INNER WEST

DEVELOPMENT ASSESSMENT REPORT

Application No.	DA/2023/0200
Address	20 Fort Street PETERSHAM
Proposal	Alterations and additions to an existing dual occupancy and landscaping works
Date of Lodgement	22 March 2023
Applicant	Ms Jianing Liu
Owner	Mr Ziqun Zheng Ms Jianing Liu
Number of Submissions	Initial: One (1)
Value of works	\$794,000.00
Reason for determination at Planning Panel	Section 4.6 variation exceeds 10%
Main Issues	<ul style="list-style-type: none"> • Permissibility • Clause 4.6 request to vary the maximum floor space ratio under the <i>IWLEP 2022</i> • Solar access and overshadowing
Recommendation	Approved with Conditions
Attachment A	Recommended conditions of consent
Attachment B	Plans of proposed development
Attachment C	Section 4.6 Exception to Development Standards

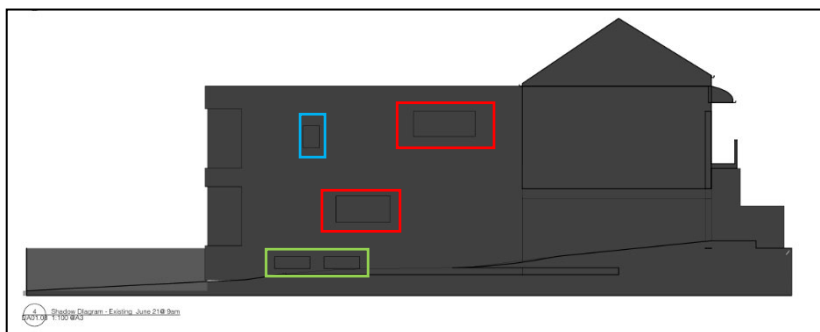
- The subject site is located within the R2 Low Density Residential zone under the *IWLEP 2022*. The neighbouring windows face the western side boundary (shared with no. 20 Fort Street), and are constructed to the boundary; thus, solar access to these windows is difficult to protect, particularly given the north-south orientation of the sites. It is noted that these are not operable windows and are comprised of glass blocks. These windows are not the primary source of light to the associated rooms they adjoin as there are operable windows on the ground and first floor which provide solar access to these spaces at present.

- Given the orientation of the site, the windows located along the western elevation of no. 18 Fort Street do not currently receive solar access until 1pm on 21 June. While solar access to the ground floor window is almost entirely lost as a result of the proposal, solar access is still provided to the first-floor window serving a secondary lounge from 1pm and will be only partially overshadowed.

- Notwithstanding the above, the lower ground floor contains a rumpus room which is not the primary living area but does have an alternate north facing operable opening, whilst the ground floor window on the western elevation of 18 Fort Street that is affected by additional overshadowing by the proposal serves a living room/ kitchen area. This space is open plan and contains operable openings along the eastern and northern elevations ensuring that this room serving the primary living area still receives compliant solar access and the glass block windows located on the western boundary are a secondary source of light to this space and should not be relied upon for solar access.
